Correction in Calculation of scale factor of the additional receiver noise, g_{an} , in COM Matlab Code

COM Commit Request Number 4p8_3

**Hossein Shakiba
Huawei Technologies Canada
May 2025**

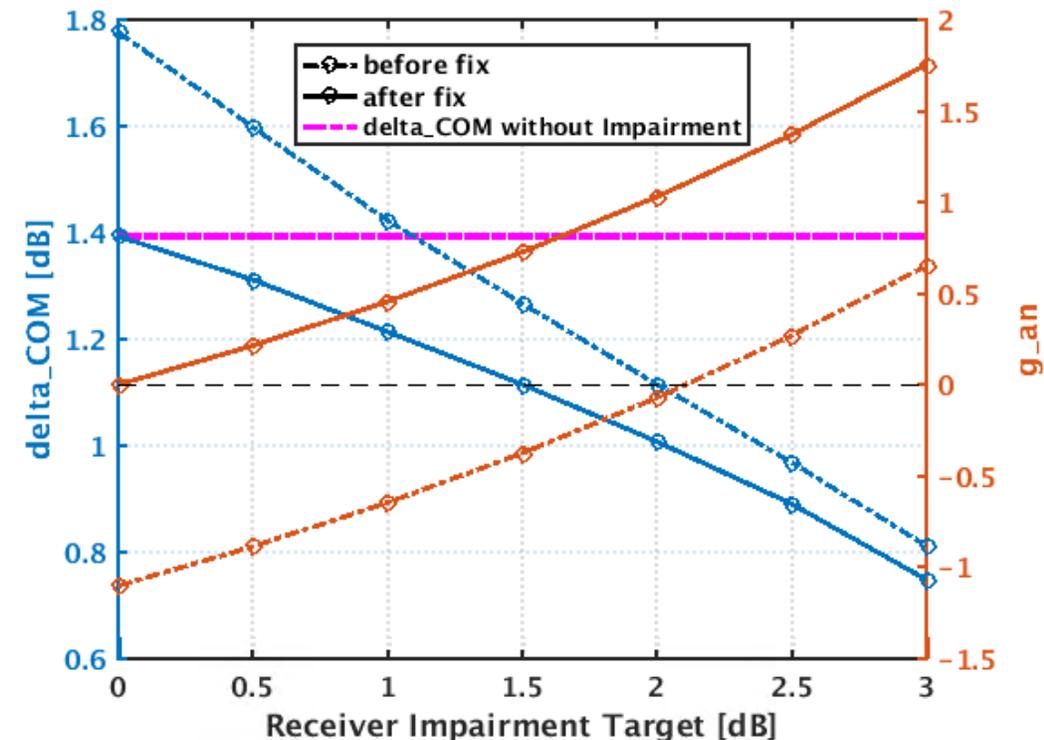
- This issue can result in a negative g_{an} , expected to be positive (see Line 20, page 784 of D1.5):

- Without a fix, g_{an} will become negative when $\sigma_{an_2_pdf} < PSD_{results} \cdot S_G_rms$:

- This will happen at a target δ_{COM_an} level that corresponds to the above inequality

- This can be immediately seen if this target is set to 0, which forces $\sigma_{an_2_pdf} = 0$, whereas for a zero target $g_{an} = 0$ is expected

- Sample COM results of a test case confirm that:

✗ Before fix, g_{an} becomes negative for scale target $< \sim 2.1$ dB

✗ Before fix, δ_{COM} is an over-estimate and exceeds its maximum allowed level

✓ After fix, g_{an} always stays positive and approaches 0 as scale target approaches 0

✓ After fix, δ_{COM} approaches its maximum allowed level as scale target approaches 0
